10. *The Park Advisory Board recommends that the Planning Commission and the Board of County Commissioners include the following conditions when considering and/or approving the Paint Brush Hills Filing No. 14 Final Plat: (1) Provide to El Paso County a 25-foot trail easement along the northern boundary of Paint Brush Hills Filing No. 14 Final Plat, within Tract A, that allows for the construction, maintenance, and public access of the Arroya Lane Primary Regional Trail, and dedicate the aforementioned easement to El Paso County prior to the recording of the Final Plat; (2) The developer will relocate the proposed storm facility from Tact A to allow the trail to be constructed on the trail easement or provide the trail easement through lots 24-30.*

STREET IMPROVEMENT PLANS

PAINT BRUSH HILLS FILING NO. 14

PROJECT NO. 10-014	FILE: \dwg\Const\dwg\Street & Storm Plans\SI18-19.dwg
DESIGNED BY: JWP	SCALE: 12/29/2020
DRAWN BY: JWP	HORIZ: 1"=50'
CHECKED BY: GW	VERT: N/A
SHEET 19 OF 30	
SI19

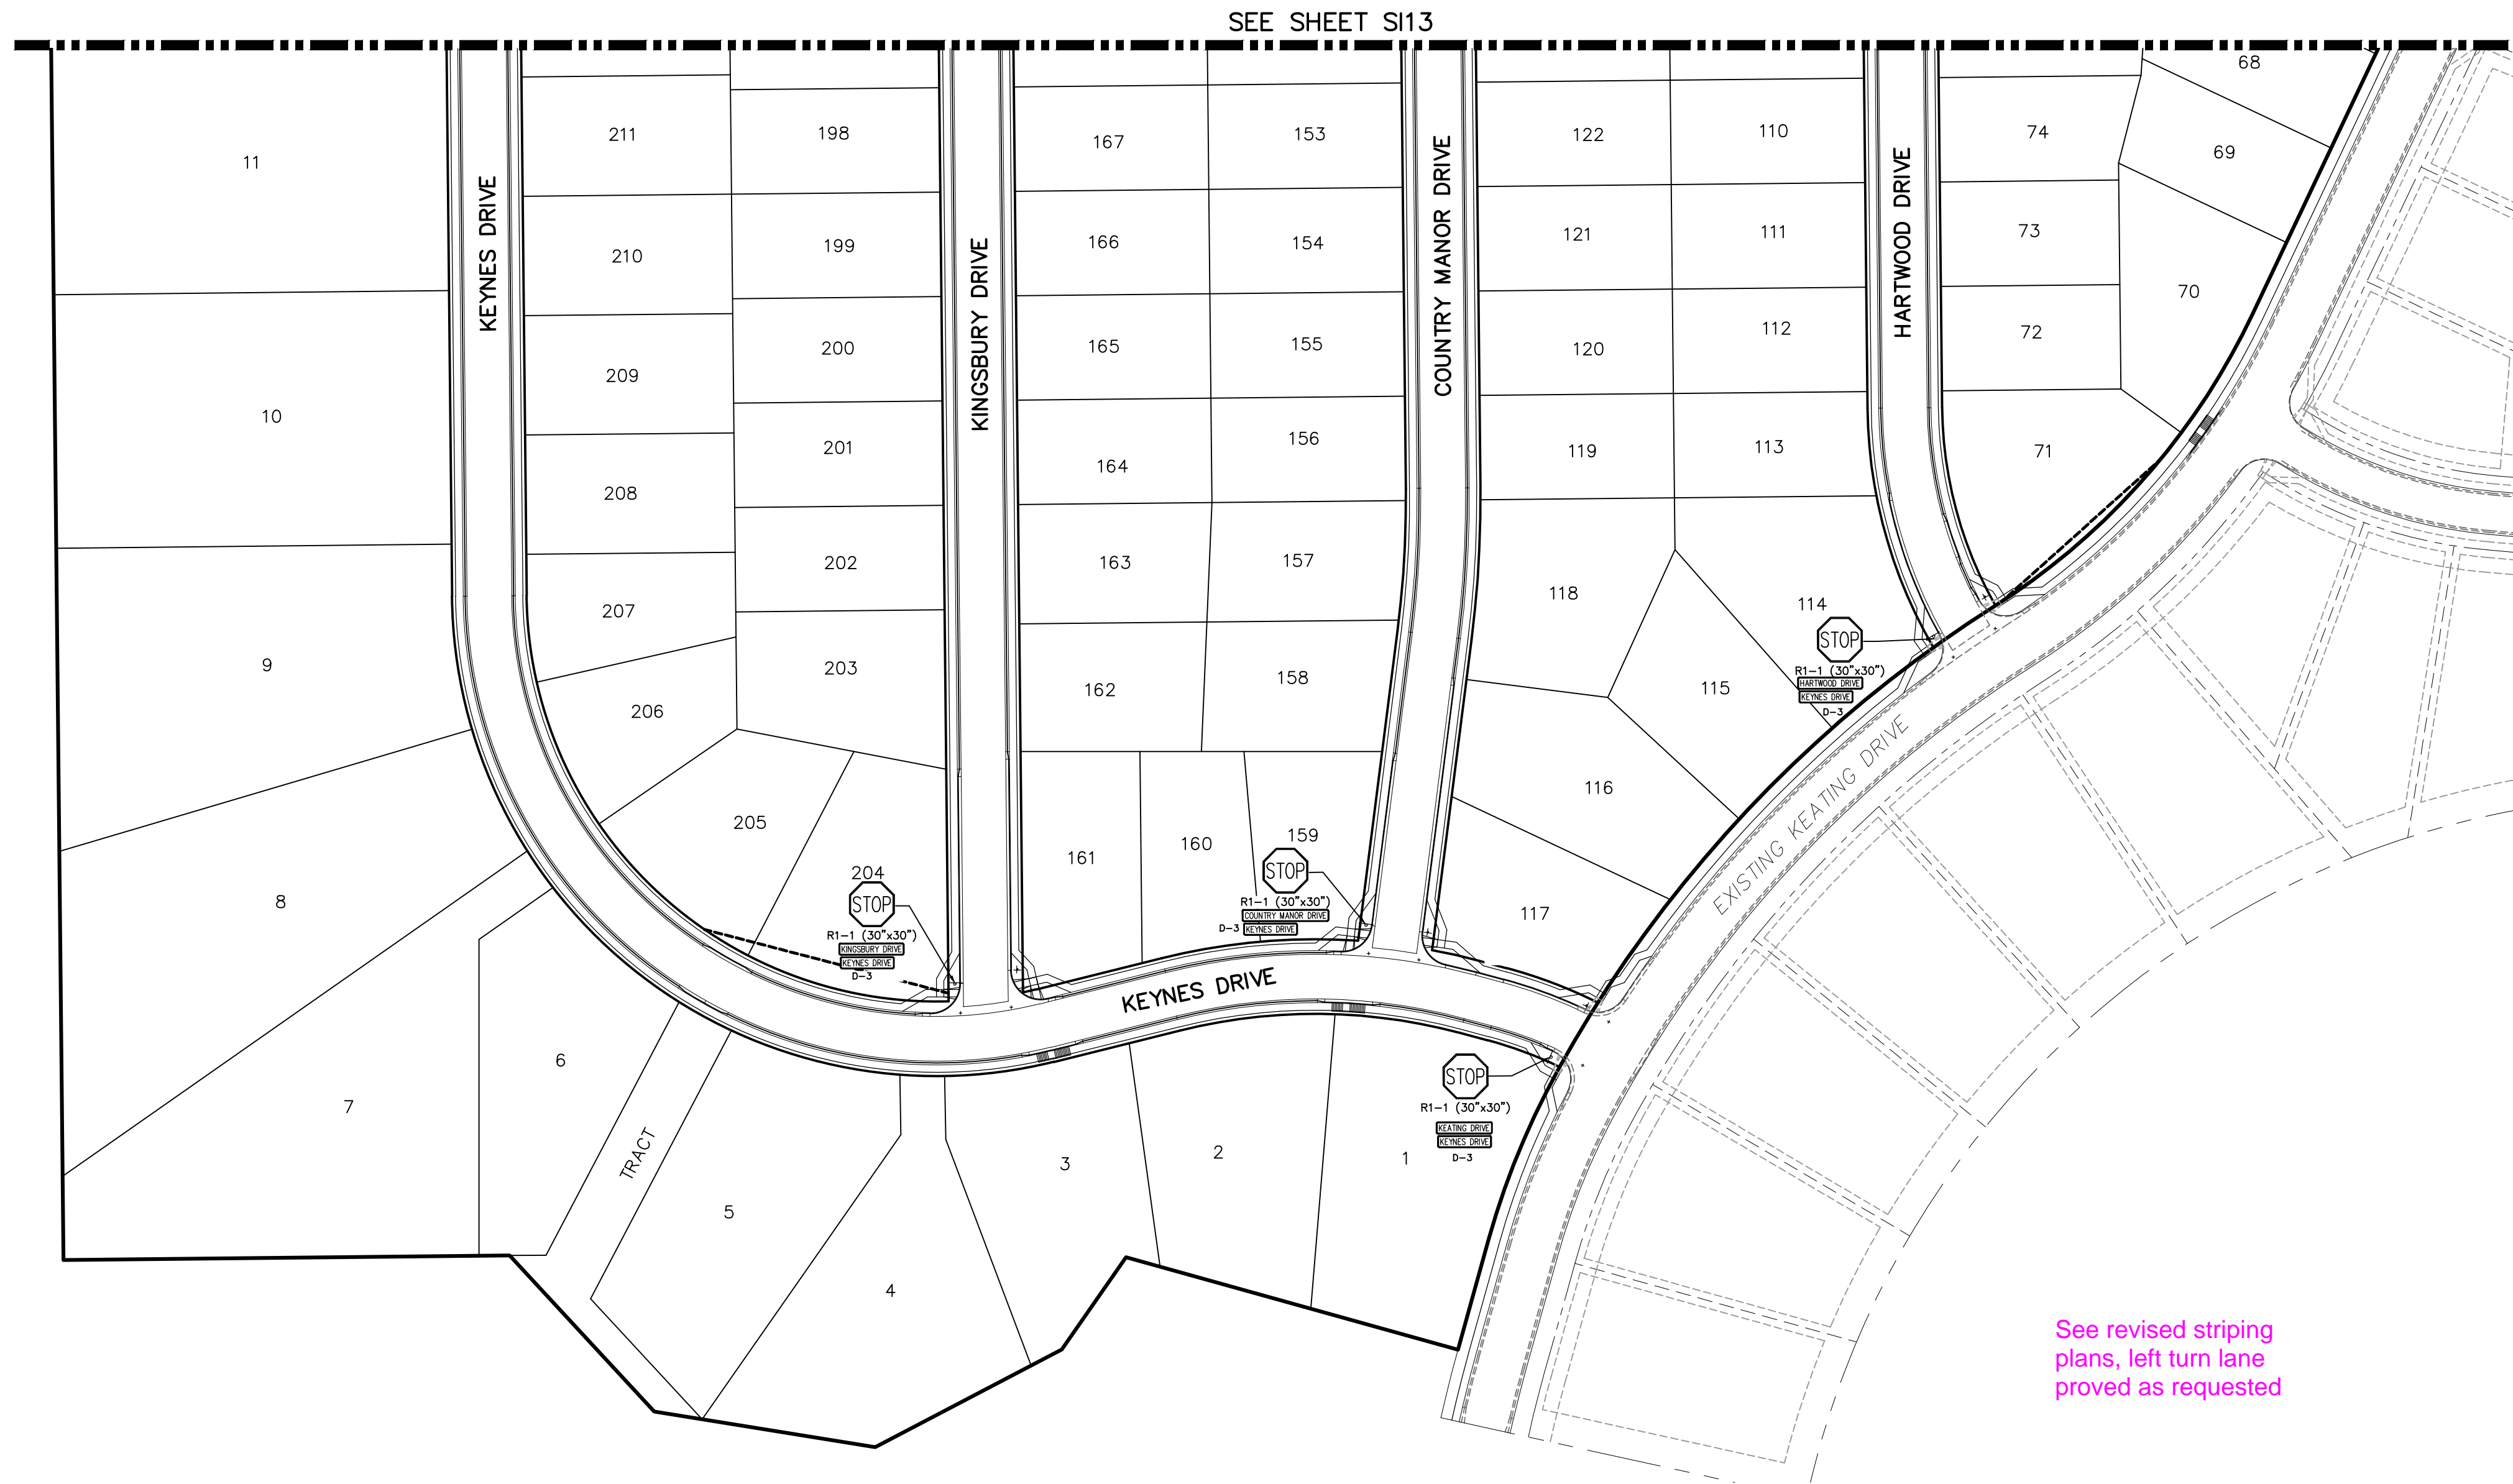
Provide offsite improvements per the TIS recommendation.

Unresolved. Update signage & striping plans to show the restriping on Londonderry per the approved deviation request.

See revised striping plans, left turn lane proved as requested

The deviation request has been upload to eDARP under the preliminary plan application (SP206)
